STREET CROSS-SECTIONS

RESOLUTION 2021-13

LOCAL STREET CROSS SECTION #2

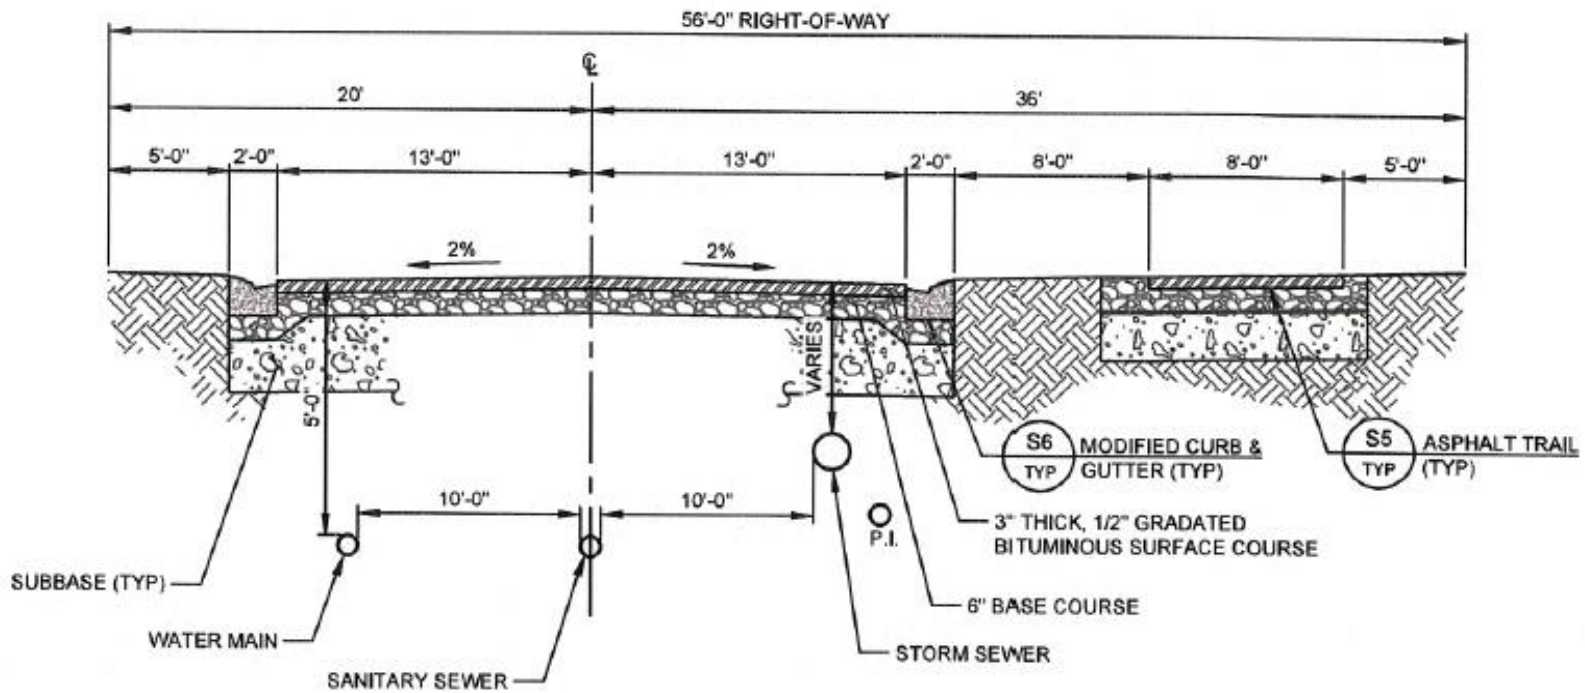
- Pavement has been reduced from 30' to 26'
- Park strips have been widened from 5' to 7'

LOCAL STREET CROSS SECTION #3

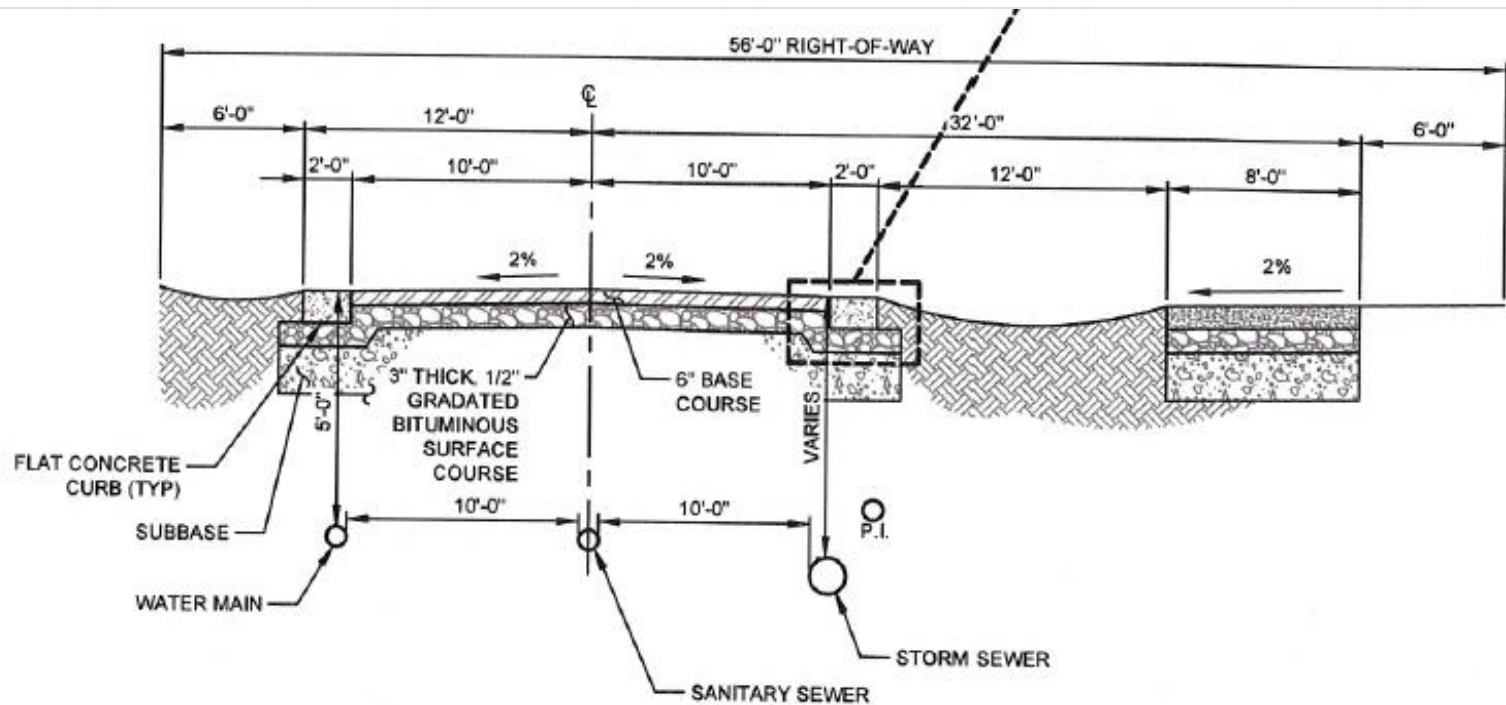
- Pavement has been reduced from 30' to 26'
- Road has been adjusted to allow for equal setbacks
- Consider 40' setback requirement
